**Jean Fraser - Re: 133 York Street/Harborview Flats**

**From:** "McGee, Martin" <Martin.McGee@FMR.COM>  
**To:** "'JF@portlandmaine.gov'" <JF@portlandmaine.gov>  
**CC:** "'mcgeekm@verizon.net'" <mcgeekm@verizon.net>  
**Date:** 10/11/2013 10:53 AM  
**Subject:** Concerns and Questions regarding 133 York Street

**From:** Erin Foley <efoley19@aol.com>  
**To:** Jean Fraser <JF@portlandmaine.gov>  
**Date:** 10/22/2013 4:47 PM  
**Subject:** 133 York St

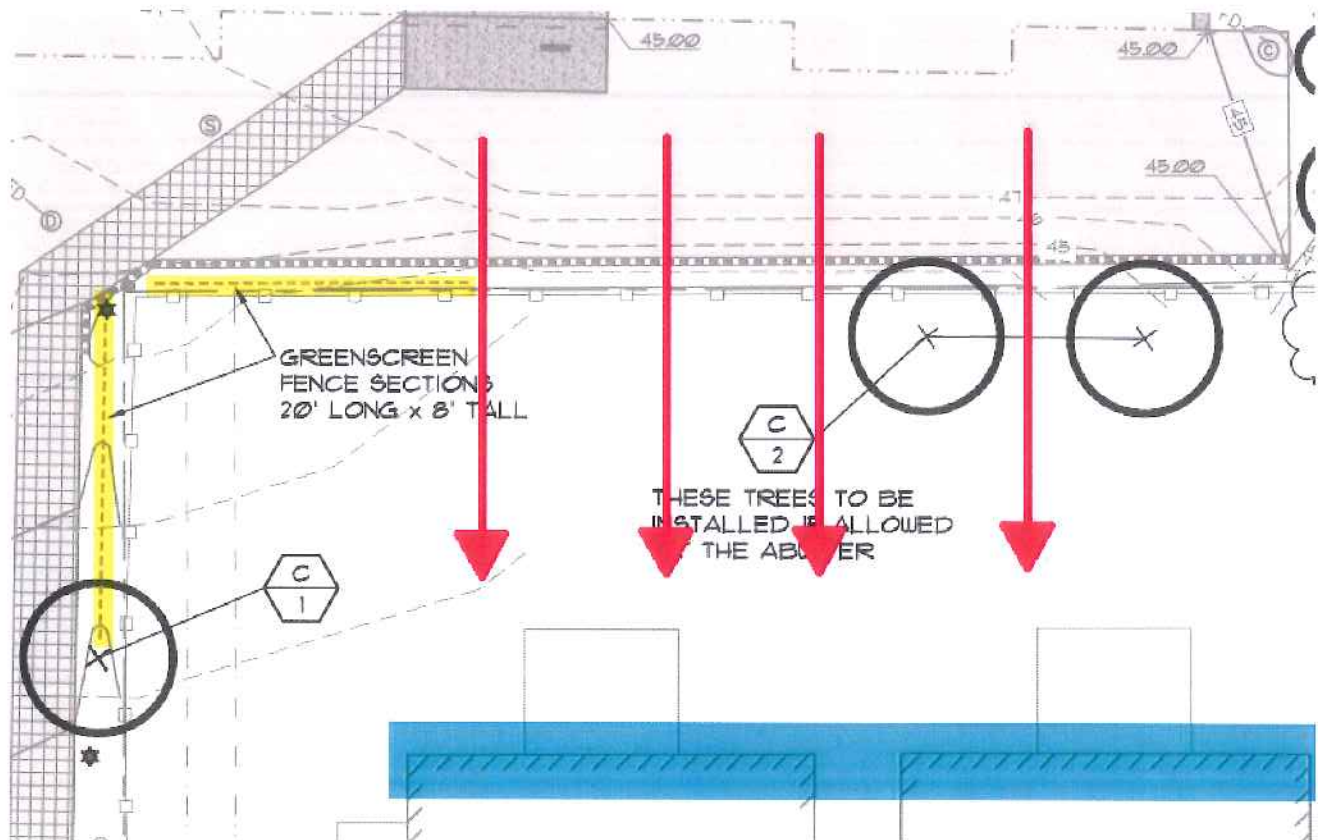
Below is an updated image with the green wall highlighted in yellow. The areas noted in blue (below) are our primary concern; hence the placement of the green wall is puzzling to me. Perhaps our concerns were not clearly stated.

AS the plan sits, the headlights from cars that are backed into your parking area will shine directly into the first floor condos (in blue) at the Flats. This unscreened area is noted with the red arrows above. The green wall and trees (as they are currently proposed) will not adequately address our concerns.

I see your concerns about the headlights as illustrated by the red arrows. I have asked the engineer to update the site plan to show a "green wall" to continue all the way across the fence. I will keep you updated on the façade.

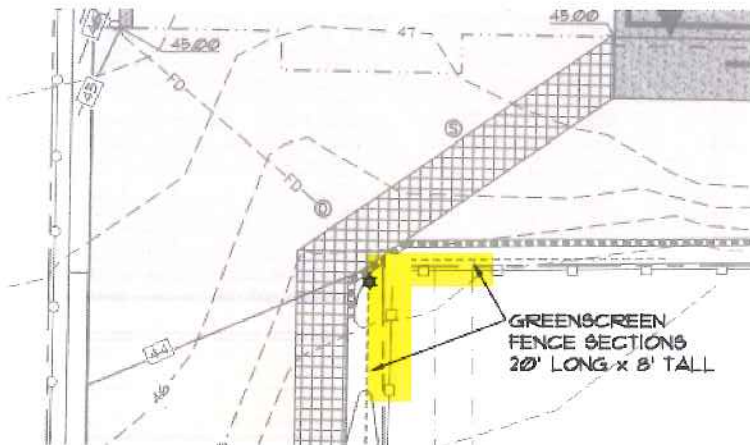
- 1) In your present design, is the green wall only planned for the section that is highlighted in yellow in the image below (the corner area)?
- 2) If YES, what provisions (beyond the trees you cited) have you made for affording the Flats screening and privacy from the parking area?

3) And finally, do you have any plans for providing privacy or screening to the adjacent Townhomes building?

1) The green wall goes beyond what you have highlighted, it is represented by the dashed line. It goes to about where the front door is located and further down the driveway.

2) The additional provision is in fact the two trees on the plan – this was suggested by the city arborist. We have added the trees and green wall to help with the privacy concerns.

3) The extra privacy for the town homes is provided with the additional 12 trees and shrubs as detailed on the plan.

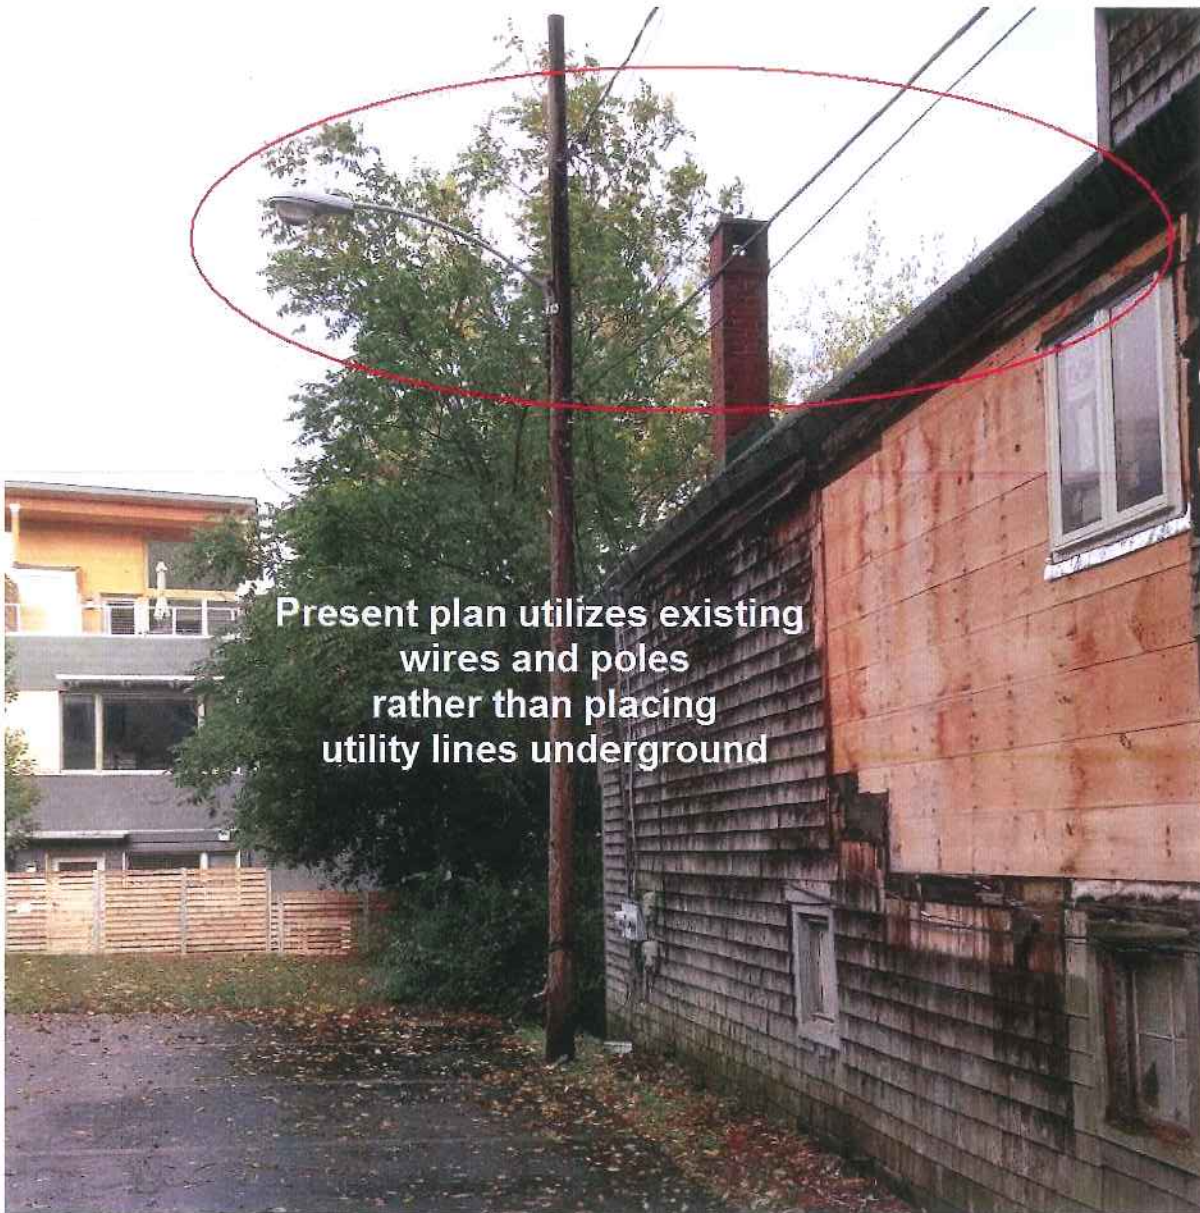
McCormick Place parking spaces are 42" from the edge of the existing building on 133 York

Photo to the right is an enlargement of the photo above showing the distance between the existing building and the cars parked in the McCormick Place parking lot

*Flat Roofed  
Buildings  
in Surrounding  
Neighborhood  
Shown Above*

*Proposed  
Building for  
133 York St  
to the Left*

**Present plan utilizes existing  
wires and poles  
rather than placing  
utility lines underground**

2. This building does not fit in with the feel of the neighborhood. According to R-6 Design principles and Standards " A building design shall contribute to and be compatible with the predominant character-defining architectural features of the neighborhood" "they have a public responsibility to add to and enhance the neighborhoods in which their projects are built." This building is less than 100 feet from the historic district and within the West End. Most homes within the neighborhood maintain historic qualities or make an effort to blend in with the feel of the neighborhood. See image 2 .

This related to our parking spaces, where due to safety reasons, I believe we will not be able to use the 5 spots abutting the construction site. Currently there is less than 4 ft from our parking lot to their property. See image 1.

8. We are concerned about the electrical lines that run to this property. Is there any plan to update the electrical lines or bury them? Currently they run from the opposite side of Park St through multiple trees to a telephone pole. From the pole they precariously run to the building. 3. Availability and adequate Capacity of public utilities. b. Electrical services shall be underground unless otherwise specified for industrial uses, or if it is determined to be unfeasible due to extreme cost.
